NEAS REFERENCE: DEA/EIA/0001556/2012

DEA REFERENCE: 14/12/16/3/3/2/441

RE: OBJECTION AGAINST THE PREFERRED ALTERNATIVE; PROPOSED ARIES-HELIOS 765KV TRANSMISSION POWER LINE AND SUBSTATIONS UPGRADE

Figure 1: Mokgope Consulting CC source

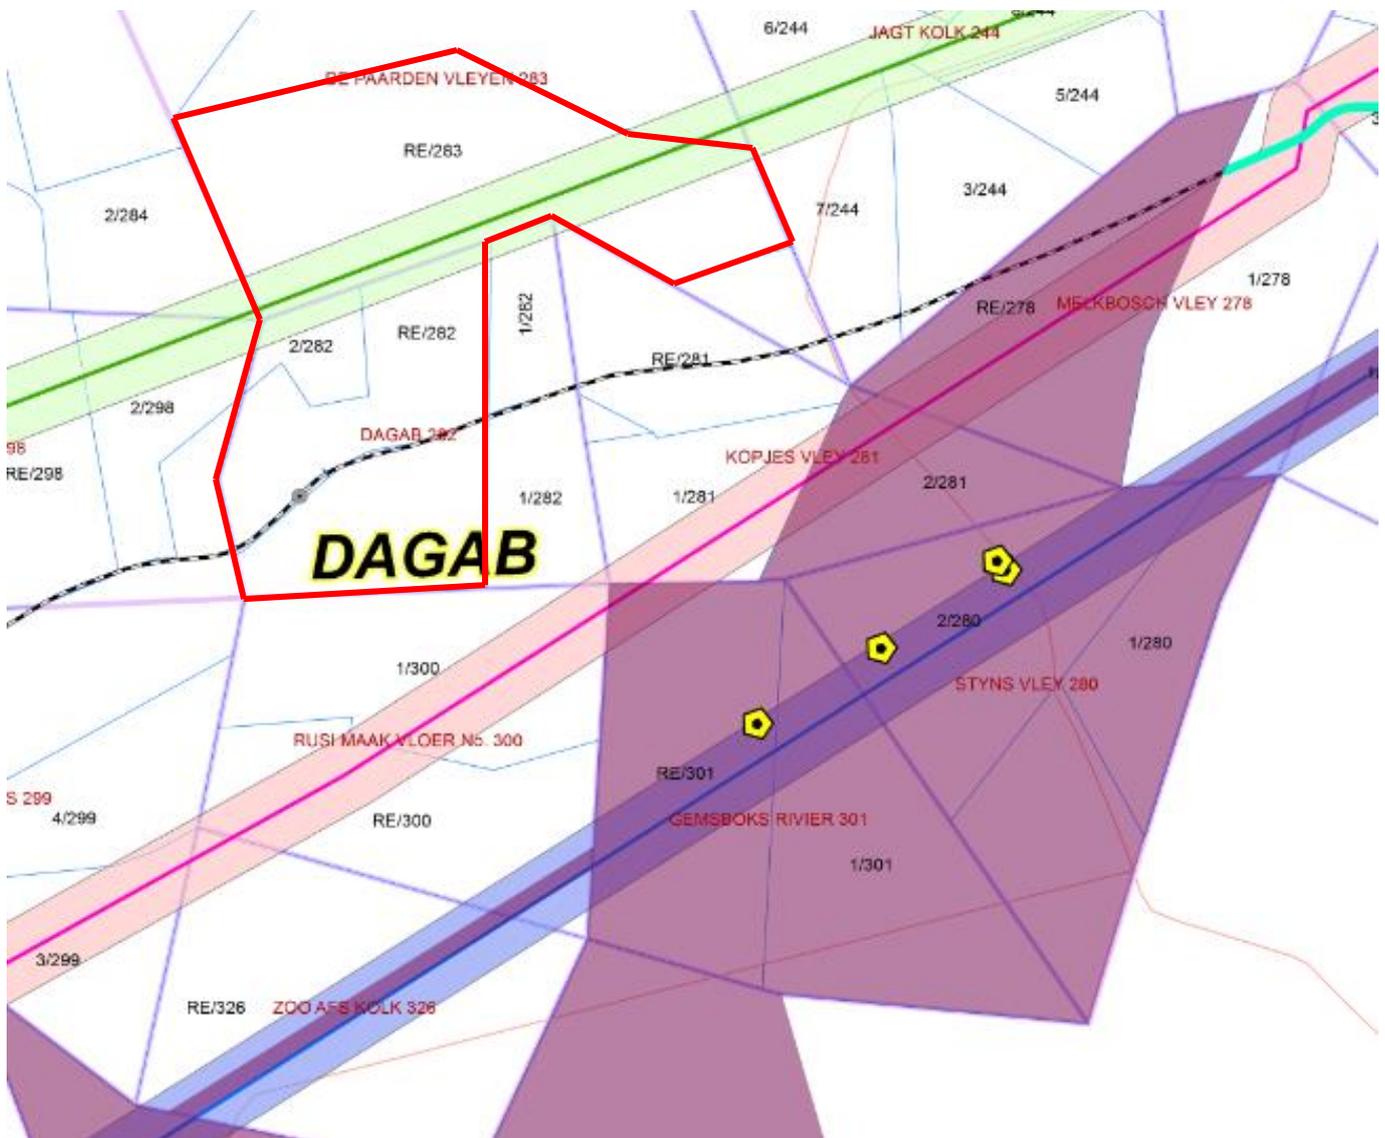
PHS Consulting act on behalf of **Mr Basson of Leopont 340 Properties Proprietary Limited t/a Dagab Boerdery** called Leopont for the purpose of this objection. Leopont is the owner of RE/282; 2/282 and Re 283 indicated on figure 1 below.

Leopont **does not support the preferred Corridor 3**, we are of the opinion that **Corridor 1 should be preferred**. Leopont will not provide consent for a servitude dissecting their farm along the Corridor 3 route, therefore making this alternative not feasible.

It is unfortunate that we are only getting involved with this EIA at such a late stage. Our comments could have been helpful in concluding the preferred alternative. According to our records the landowner Leopont never received any formal notification of the proposed development. We kindly request that you provide us with proof of notification to Leopont 340 Properties Proprietary Limited t/a Dagab Boerderij the owners of the following farms RE/282; 2/282 and Re 283.

Figure 2: Seven Solar Reserve components. CSP 3 was approved and CSP 2 & 1 is in process.

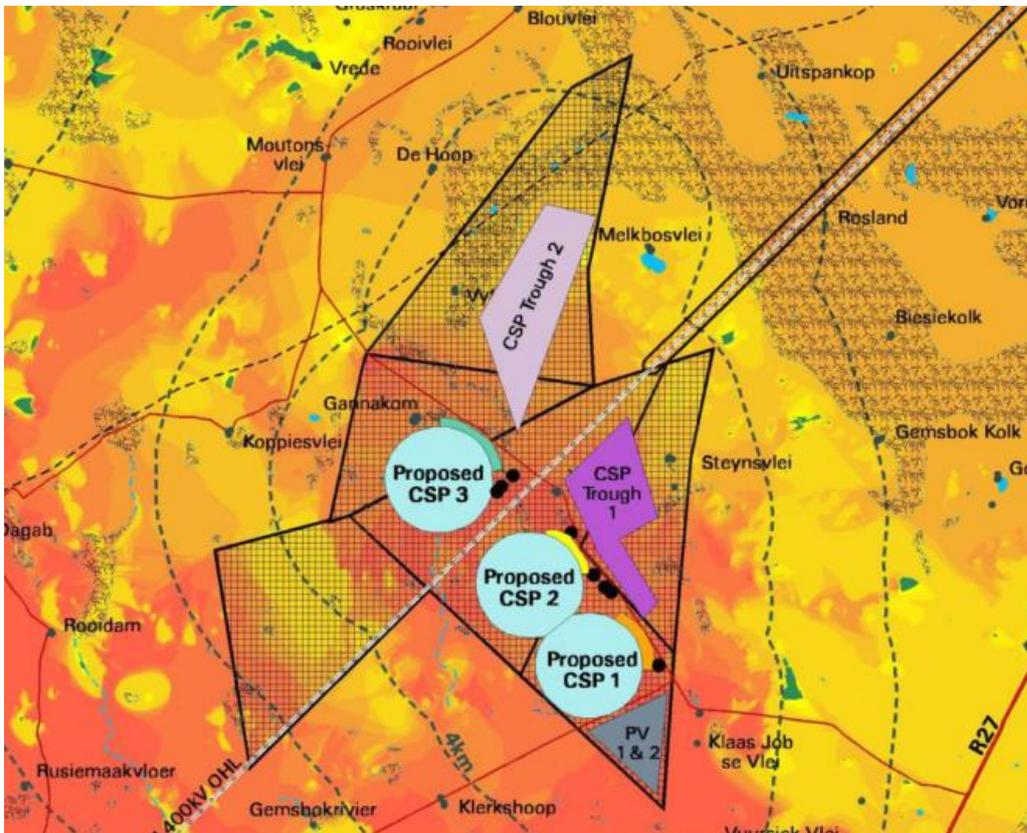
The proposed Eskom transmission corridor alternatives clashes with the recently approved CSP 3 (DEA REF: 14/16/3/3/2/694) it also clash with the CSP 1 & 2 (DEA REF: 14/16/3/3/2/694/1 & 2), EIA that is still in process. These transmission corridors also clashes with further expansions proposed on the Solar Reserve, see figure 2 below. We have questioned the legitimacy of the CSP 3, EA on cadastral portions that is currently involved in your EIA process. We propose that you alert DEA about this clash and how it could jeopardize the outcome of your application.

The Eskom Corridor 1 clashes with CSP 2 & 3 and CSP Trough 1. The Eskom Corridor 2 clashes with CSP 3 and CSP Trough 2. The Corridor 3 does not clash with the Solar Reserve, but it does with our expectations. This makes the Solar Farm project not feasible at this point in time. The Applicant in the Solar Reserve case indicated the current powerline but did not consider the 2 km wide corridor proposed by Eskom, neither did they consider the fact that their project is only feasible if the transmission lines are upgraded, without an upgrade the current lines can't transfer the generation.
